# Plan Commission

### Agenda

| Monday, January 23, 2017 | 7:00 PM | De Pere City Hall Council Chambers |

**SUBJECT:** Recommendation regarding a Revised Site Plan request at 1212 N. Enterprise Drive in De Pere for a warehouse addition and parking lot expansion (Parcels ED-2070 and ED-2069). Applicant: Mach IV Engineering & Surveying LLC

SHEET:  
C2.0

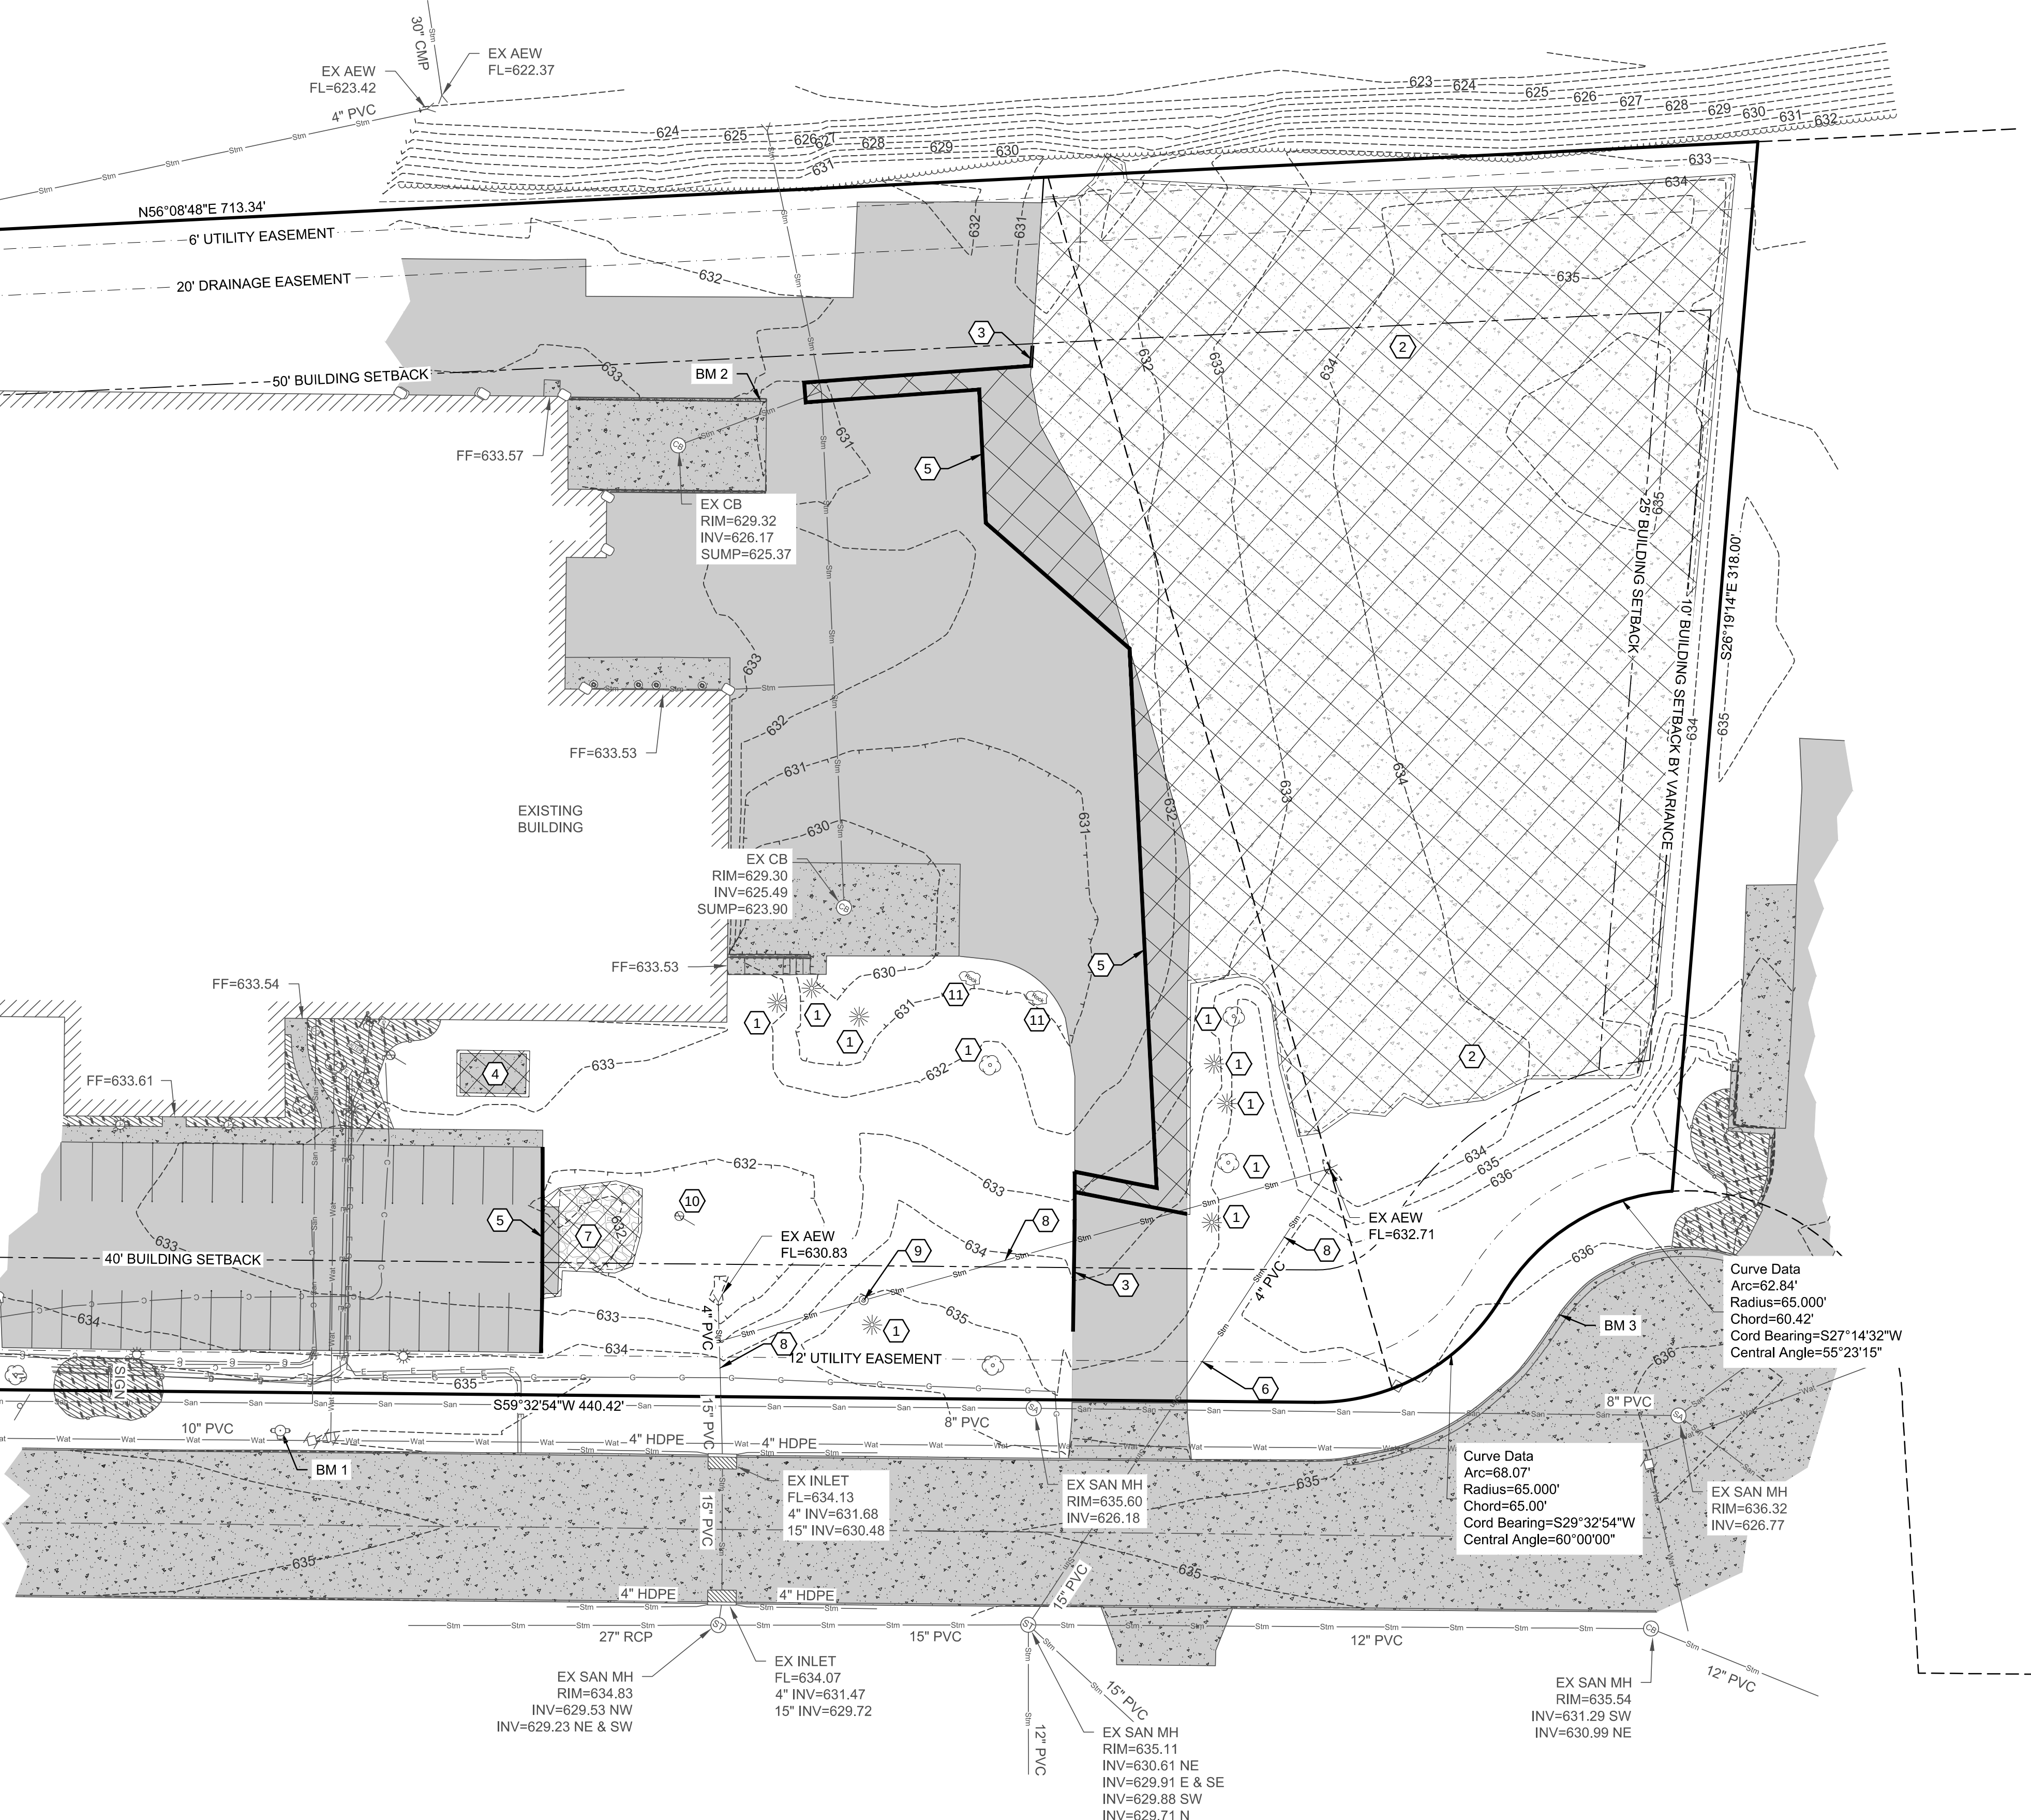
3. There is a 5-foot by 5-foot paved area (site plan page C2.0), and a new 36-foot wide asphalt area on the north side of the proposed building (site plan page C1.0), within the 50-foot setback that is enforced by WisDOT. Obtain proper approvals from WisDOT to be able to develop within the setback and provide a copy to City of De Pere for files.
4. Front future addition to be constructed within a five year time frame from the date of the last site plan review or the building will need to be brought into compliance with material standards. The established five year timeframe for compliance is November 28, 2021.

1. Existing Conditions Sheet C1.0 - Comment two says to remove/salvage "GRAVE" instead of "GRAVEL". Noted and changed.
2. Pursuant to Municipal Code 14-60(9)(2)(h) need to show the dimensions of the adjacent right-of-way and roadway. Added. See Sheet C2.0

9. On the Site Plan Sheet C2.0 show adjustments for the water valve and the sanitary clean-out referenced in comments 9 & 10 on the Existing Conditions Sheet C1.0. Addressed. Pipes/valves/cleanouts shown are NOT sanitary or water laterals. They are on-site storm sewer and irrigation and have been addressed (removal, and protect in place).

4. Add Floor Area Ratio to the 'Site Statistics' Chart on sheet C2.0. **Added. See Sheet C2.0**
5. Landscape plan listed on 'Civil Sheets Index' may requires revision based on discussions with Mach IV. Re-submit landscape plan that meets Code Section 14-60. **Added. See Sheet L1.0**
